In the matter of an application for approvals in relation to the Waitaha Hydro Scheme

**EXPERT PANEL: WESTPOWER LTD MEMORANDUM #6  
MEMORANDUM OF COUNSEL RESPONDING TO RFI #2 DATED 12  
DECEMBER 2025**

Dated: 16 January 2026

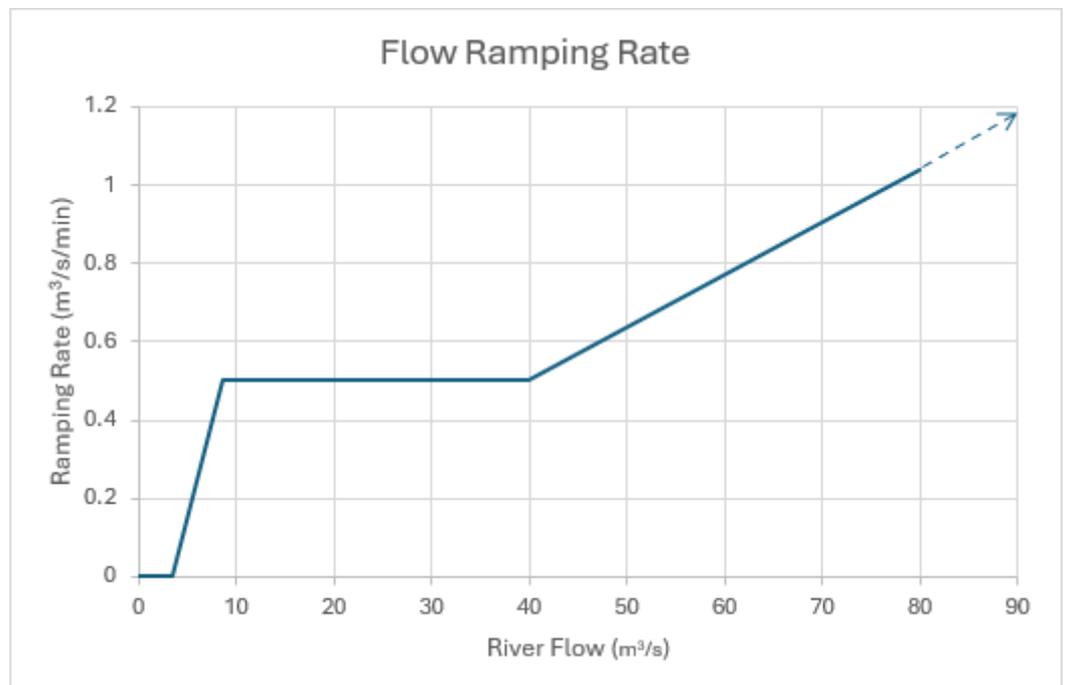
*Question 4: The Panel requires more information about ramping rates.*

*a) Whether Francis turbines have difficulty operating below 40% of design flow?*

24. Francis turbines are typically not operated below approximately 40% of their design flow, and it is not the intention to normally operate them in this range. However, this is an efficiency (and asset management) decision; the turbines can be safely operated below that level if required, while accepting some risk of increased wear if operated for long periods of time in this zone. In fact, if the Station is required to run isolated to supply local load in South Westland, it will be expected to run in this zone for as long as required. Westpower, prior to its divestment to Manawa Energy, successfully applied this operating strategy with the 3.5 MW Francis turbine at the nearby Wahapo Power Station over many years.

Figure 1 – Cross section at Chainage 1100.000

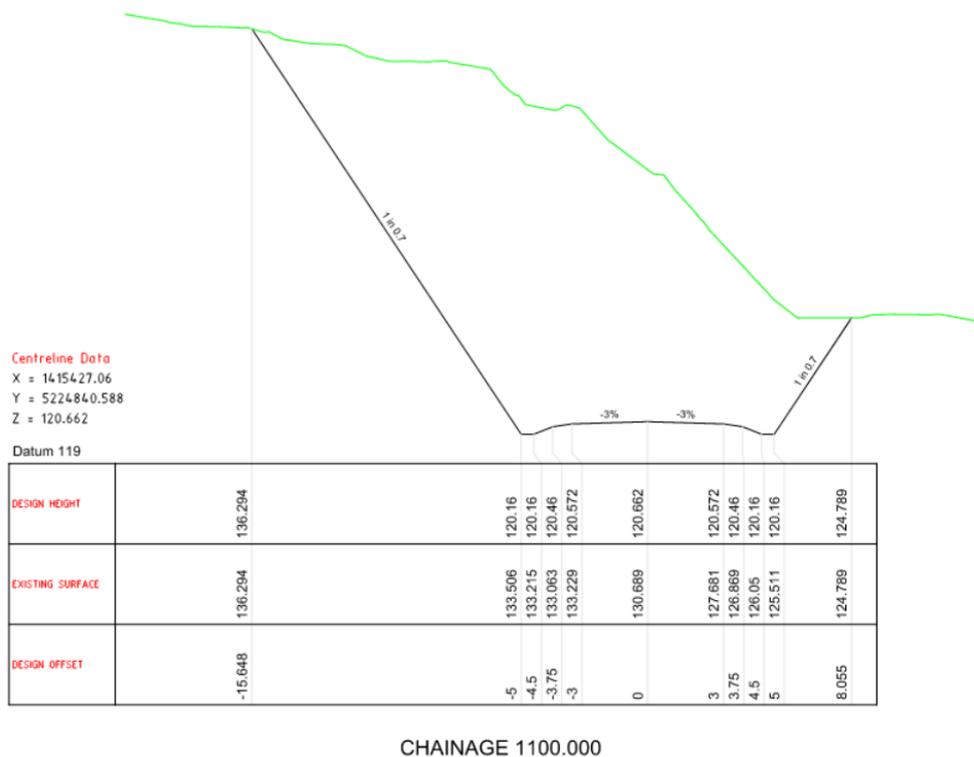
*Granite Creek Crossing - The design indicates an area of cut slope will be required just to the south of the Granite Creek crossing.*

a) *Whether the design of this cut slope has been assessed and the likely height/slope treatment determined?*

43. The slope of the cut immediately south of Granite Creek is 1 in 0.7 and has a height of approximately 16m (showing in Figure 1<sup>19</sup> below). Treatment of all slopes will be assessed by the construction manager in consultation with the DOC liaison officer and consistent with the Landscape Management Plan and the rehabilitation options.<sup>20</sup>
